**REMARKS**

Amendment  
Serial No. 09/829,788

Docket No. US 010187

FIG. 13

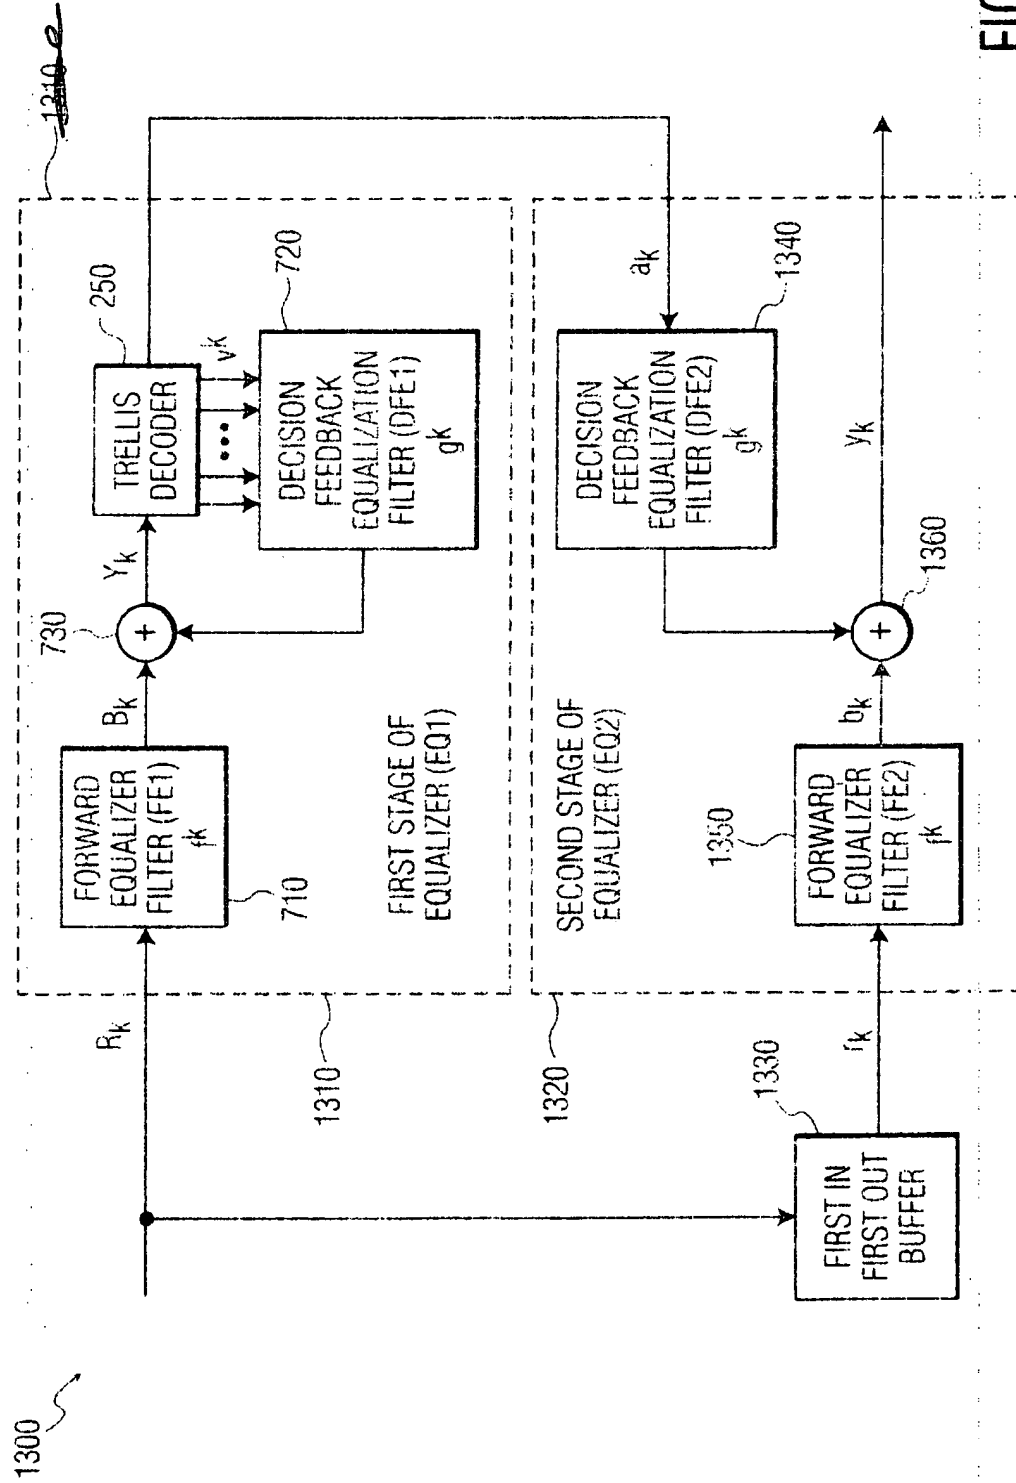
The examiner has objected to the drawings. More specifically, in Fig. 13 the reference number 1310 is duplicated.

Applicant thanks the examiner for his observation and has provided, in Appendix A, an amended Fig. 13, appropriately labeled "Replacement Drawing," which removes the duplicate label 1310. No new matter has been added as the label 1310 was incorrectly duplicated in referring to the same element when formal drawings were submitted in a letter to the Official Draftsman on April 24, 2002. Included, in Appendix B for the examiner's reference, is an annotated copy of the Fig. 13 showing the amendments made, in red, and in Appendix C the originally filed drawing Fig. 13.

Having amended the drawings appropriately, applicant believes that the reason for the examiner's objection is not longer applicable. Applicant respectfully requests that the amended Fig. 13 be entered and the objection withdrawn.
